PL201600098
PL2016-98

9101 CEDAR AVE.
CONCEPTUAL SITE PLAN

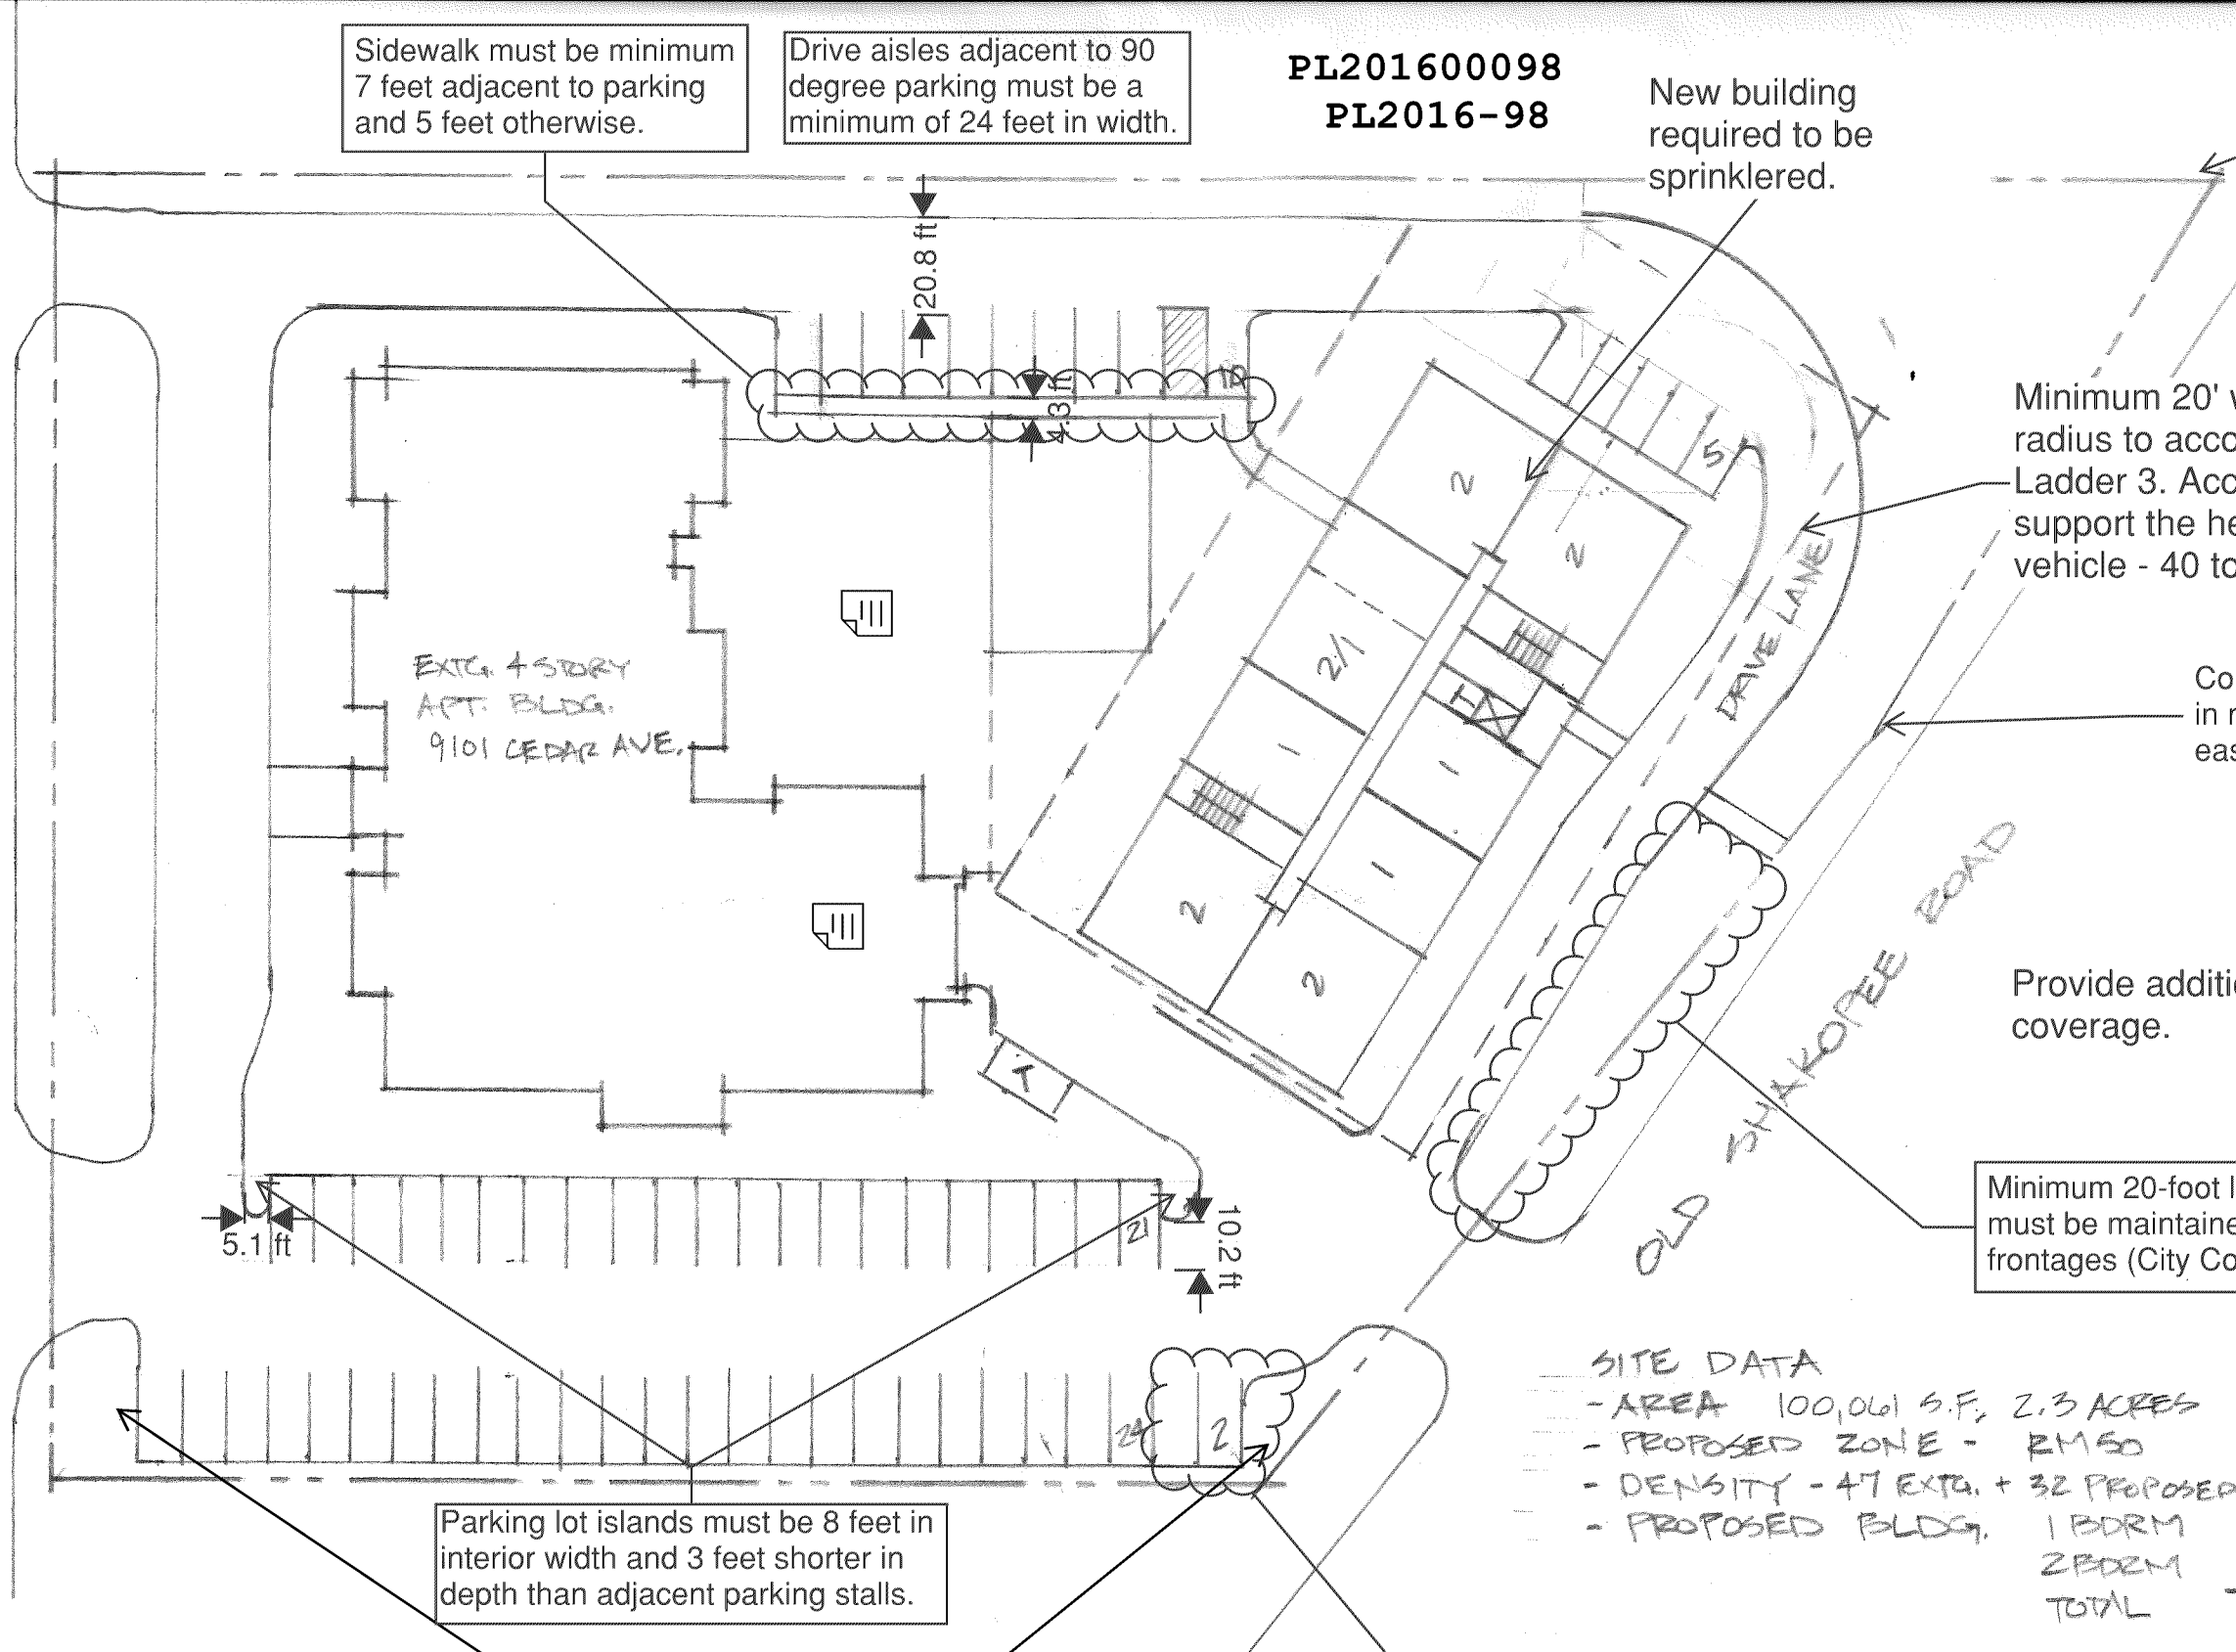
Sidewalk must be minimum 7 feet adjacent to parking and 5 feet otherwise.

Drive aisles adjacent to 90 degree parking must be a minimum of 24 feet in width.

New building required to be sprinklered.

Verify property line. City/County may need a small portion of ROW/Easement for a future project.

Minimum 20' wide with turning radius to accommodate BFD Ladder 3. Access road shall support the heaviest emergency vehicle - 40 tons.

Construct 8' sidewalk in new 12' sidewalk easement.

Provide additional hydrant coverage.

Minimum 20-foot landscape yard must be maintained along street frontages (City Code Sec. 19.52)

Minimum 20-foot landscape yard must be maintained along street frontages (City Code Sec. 19.52)

Parking lot islands must be 8 feet in interior width and 3 feet shorter in depth than adjacent parking stalls.

Must provide a solid three foot screen along any parking adjacent to the street.
